Urgent Field Safety Notice
3mensio Workstation (Vascular – Fenestrated)
Version (10.6, 10.6 SP1, 10.6 SP2, 10.6 SP3, 10.6 SP4, 10.7, 10.7 SP1)

The purpose of this letter is to advise you that Pie Medical Imaging is issuing an urgent Field Safety Notice regarding the clock position visualization in the fenestration diagram in 3mensio Workstation 10.6 (Vascular – Fenestrated layout) or 3mensio Workstation 10.7 (Vascular – Fenestrated layout).

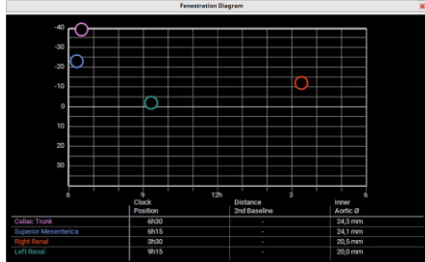
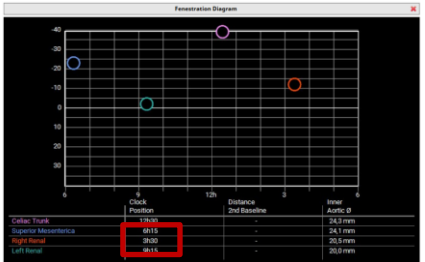
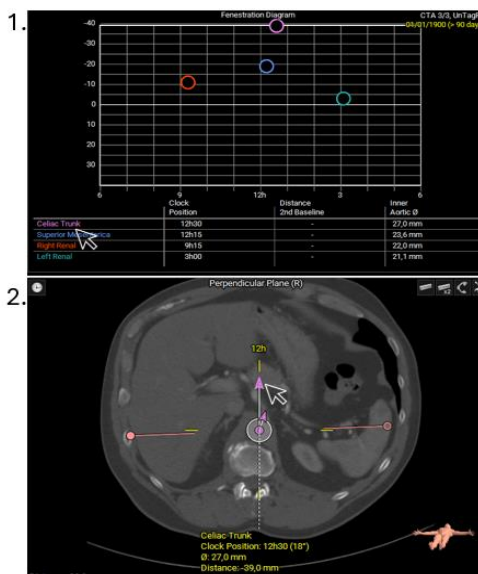
Observed behaviour: In the fenestration diagram only the adjusted clock measurement is updated to the new 12h position. The other clock measurements are not updated relative to the new 12h position

Fenestrated analysis with clock measurements started in 3mensio Workstation 10.6 (12h in AP direction)	Changing 12h position of a single clock measurement → results in an updated fenestration diagram with all clock measurements relative to this 12h
Observed		
	Opening a fenestrated analysis with clock measurements	Changing 12h position of a single clock measurement → Only the adjusted clock measurements is updated in the fenestration diagram.

Impact: The hazard exists that the clock positions are not correct in the report causing fenestrations on a stent graft at an incorrect position. This could potentially be harmful for the patient since this could potentially lead to permanent tissue damage. If FSN advice is followed there is no residual risk.

In case you open a session state with saved clock measurements created in **3mensio Workstation 10.6** and there is a need to adjust the **12h position** for the clock positions, make sure to update **all** individual clock measurements in the perpendicular plane by the following steps:

1. Click on the clock position.
2. Update the 12h pointer of the clock in the perpendicular viewport.
3. Perform step 1 & 2 for all clock measurements in the analysis.

After updating all 12h pointers, the information shown in the fenestration diagram is correct and functionality is restored.
